APPEAL OF DEPOE BAY PLANNING COMMISSION DECISION

VARIANCE
PLAN

NE BRADFORD STREET TOWNHOMES
for LISAC BROTHERS CONSTRUCTION INC.
DEPOE BAY, OR
SITE PLAN

**#2-VAR-PC-21 Lisac
Findings, Conclusions, and Final Orders**

66
A1.0
SCALE: 1:10
SITE PLAN

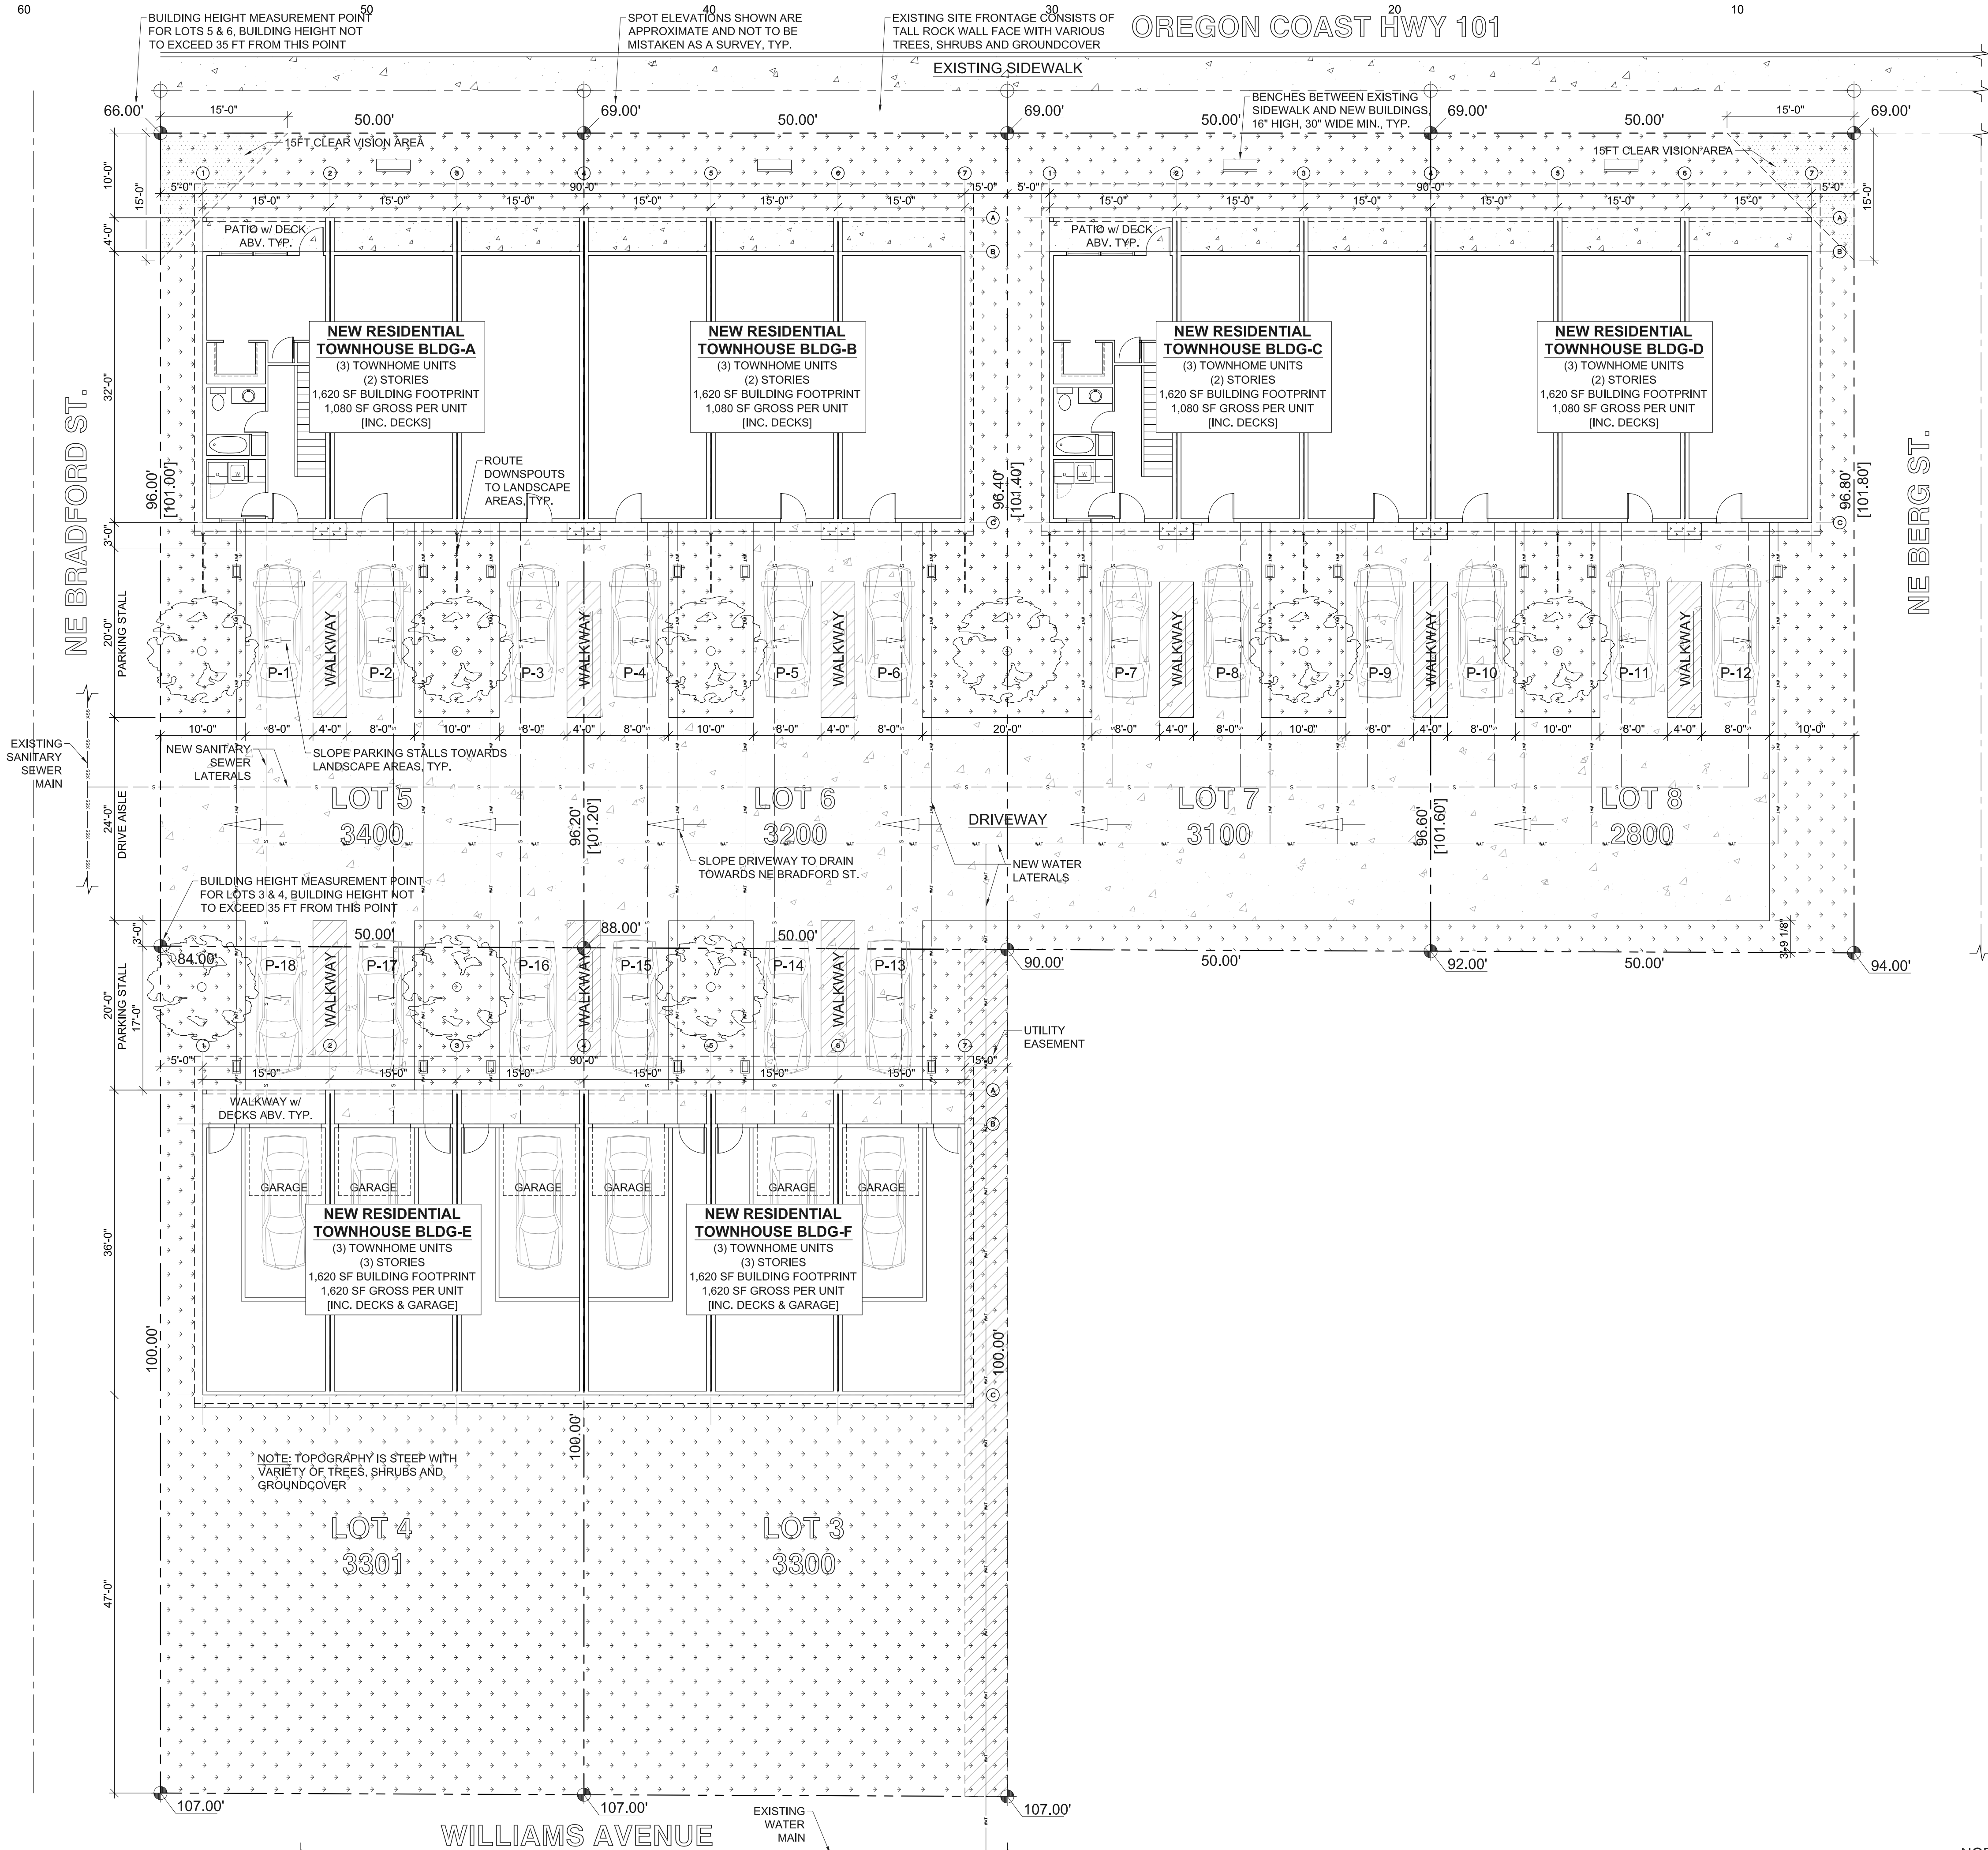
Street into the development from Bradford. Code requires a street-- it is not a driveway and parking lot
